1989 Corvette: Service Bulletin: Tire Rotation Procedure

Subject: Tire Rotation Procedure

Model and Year: 1989 Y Car with Optional Low Tire Pressure Warning System

Number: 89-299-3E

Figure 1 - Tire Rotation Pattern

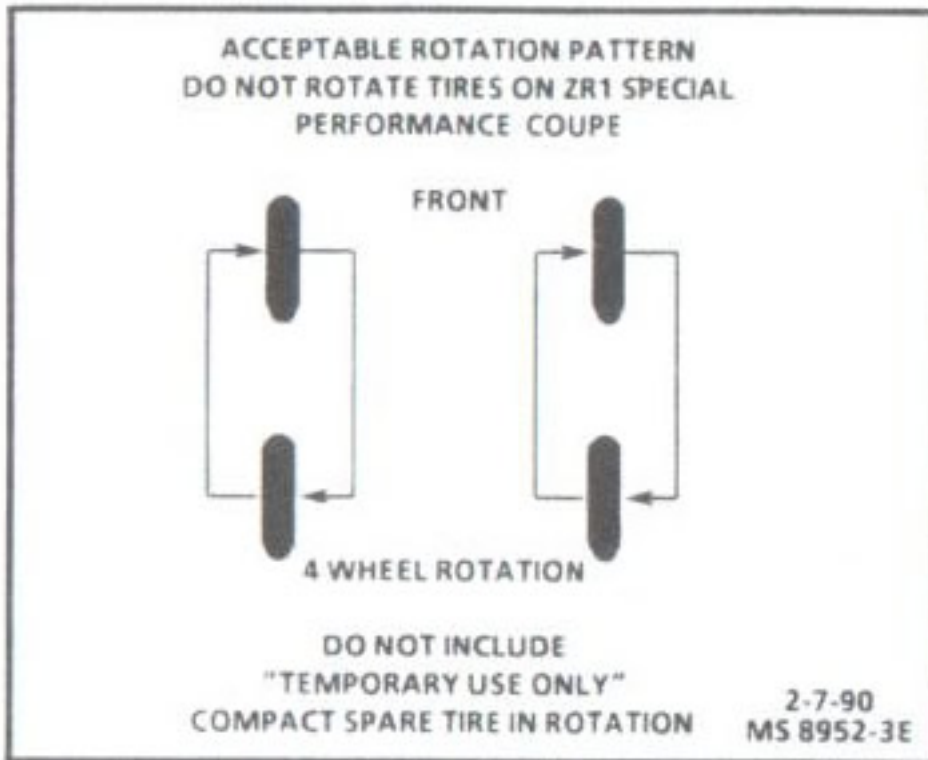
The Low Tire Pressure Warning System receiver does not recognize wheel/tire assembly location; however it does look for a particular signal from each of the four wheel transmitter/sensors. Therefore, the procedure given on the tire rotation in Section 3E of the 1989 "Y" Carline Service Manual should be disregarded. The tire and wheel assemblies on vehicles equipped with the optional Low Tire Pressure Warning System can be rotated as show in Figure 1.
